SERVICE BULLETIN

TITLE: LANDING GEAR - TORQUE KNEE INSPECTION

SYNOPSIS OF CHANGE

This revision increases aircraft serialization that requires an inspection, changes inspection intervals from hours to cycles, and adds "whichever occurs first" per FAA request, information to plug the bushing holes and document change to perform Fluorescent Penetrant Inspection. Relevant technical changes are marked with change bars in the outside margins.

**P/N 50-810032-4 Upper Torque Knee
Figure 1**

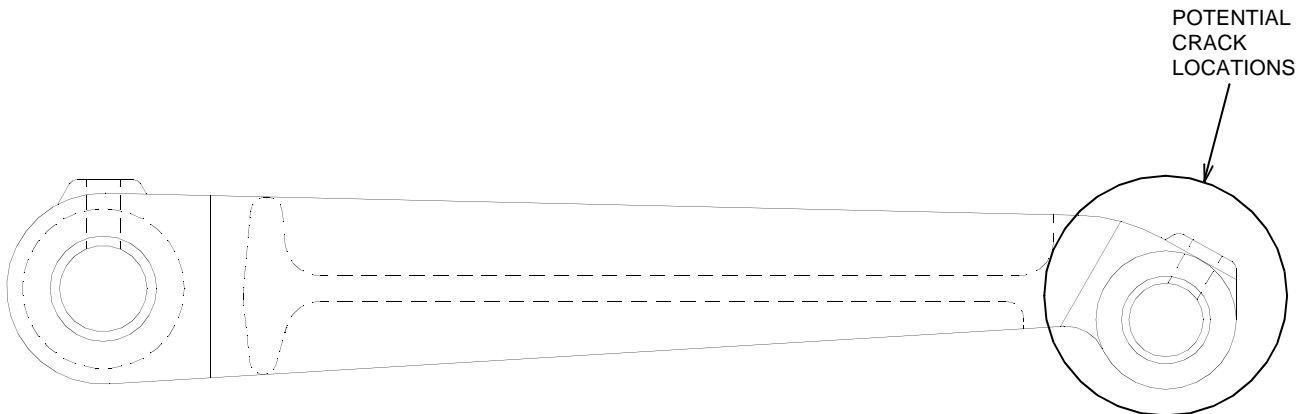
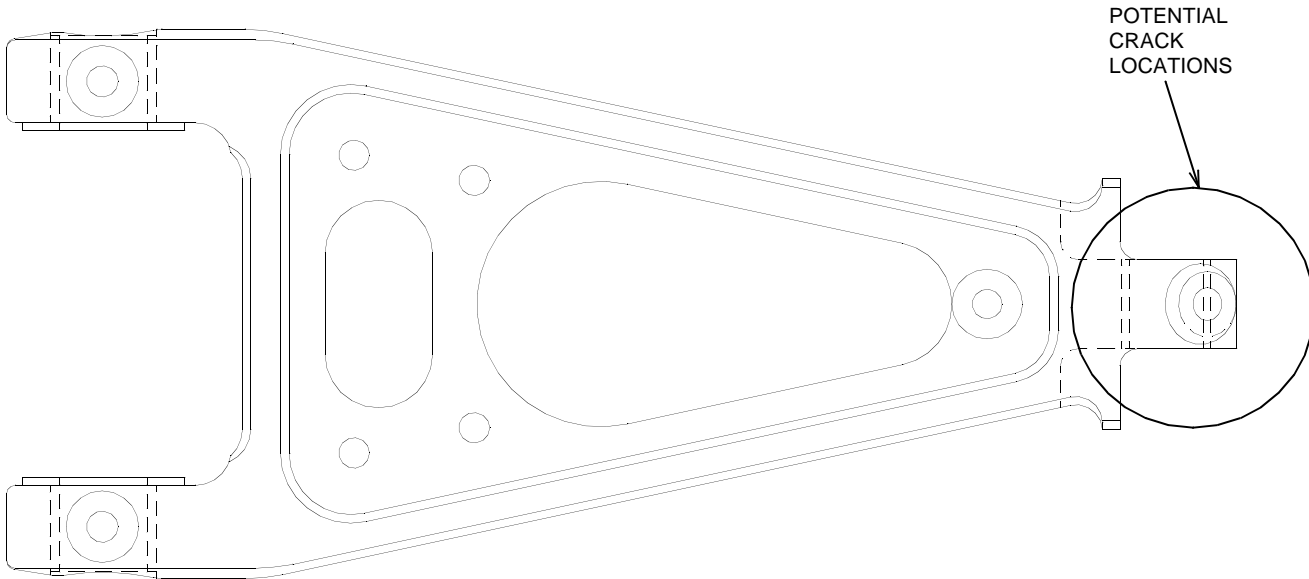
- (4) Release the air pressure entirely before removing the valve core from the shock strut.
- (5) Remove the upper torque knee from the airplane. Refer to Chapter 32-10 of the Maintenance Manual for removal procedures. Carefully inspect the complete torque knee for fatigue cracks using the FLUORESCENT PENETRANT INSPECTION methods listed on page 8. Pay particular attention, but not limited to, areas pointed out in Figure 1. Replace any torque knee when fatigue crack indications are found. If no fatigue crack indications are found, repaint the inspected torque knee with epoxy polyamide primer and urethane topcoat paint in accordance with the appropriate Maintenance Manual, Chapter 20-08.

- (8) Perform a Type I, Method C, Sensitivity Level 3, fluorescent penetrant inspection in accordance with American Society for Testing and Materials ASTM E 1417 95a on all surfaces of the upper torque knee except the inner shear web. The following considerations associated with the inspection process should be observed:

**P/N 50-810295-1/-3/-17 Lower Torque Knee
Figure 2**

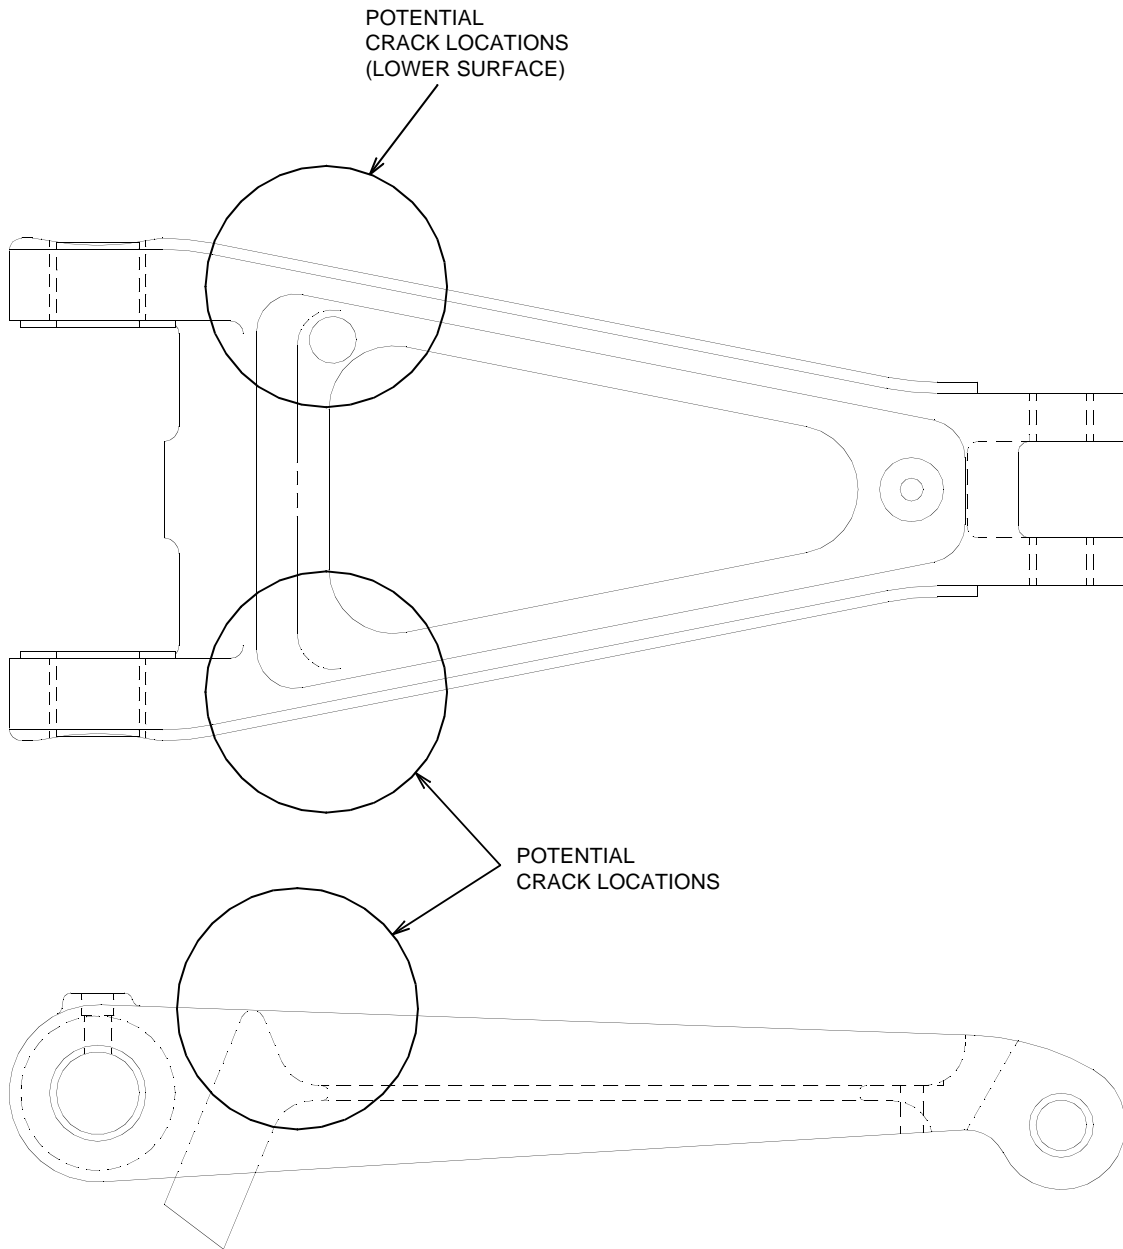
- (6) Remove the lower torque knee from the airplane. Refer to Chapter 32-10 of the Maintenance Manual for removal procedures. Carefully inspect the complete torque knee for fatigue cracks using the MAGNETIC PARTICLE INSPECTION methods listed on page 10. Pay particular attention, but not limited to, the areas pointed out in Figure 2. Replace any torque knee when fatigue crack indications are found. If no fatigue crack indications are found, repaint the inspected torque knee with epoxy polyamide primer and urethane topcoat paint in accordance with the appropriate Maintenance Manual.
- (7) Install the inspected upper and lower torque knees, or new torque knees, in accordance with the appropriate Maintenance Manual.
- (8) Remove the airplane from jacks.

The magnetic particle inspection for the P/N 50-810295 Lower Torque Knee consists of a wet continuous, fluorescent particle, three phase, full wave, direct current technique, using a pulse length of 1/2 to 1 second and is accomplished as
